Service Bulletin

Model : GP405/335

No.: GP405-008
(FF-T01-J7-000023-01)

Subject : PREVENTION OF JAM 0131

Fig. 1 Registration front guide assembly

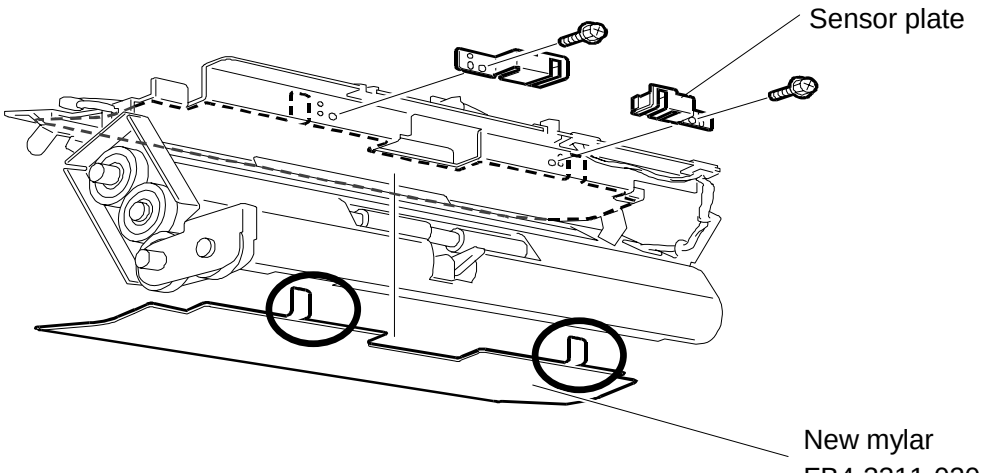
<Cause>
The mylar (FB4-3311-000) stuck to the registration front guide assembly becomes charged (depending on the environmental conditions and paper types) by the paper going past the mylar, causing the copy paper to stick to the mylar.

<Factory measure>
The following changes were made to the mylar stuck to the registration front guide assembly:

- Change to a material with high conductivity (from Corton to Tufflite)
- Change in the shape of the mylar (see Fig. 1 for the tab shapes circled) for sticking the mylar and the sensor plate together to the registration front guide assembly and for reliably grounding the charge built on the mylar surface.
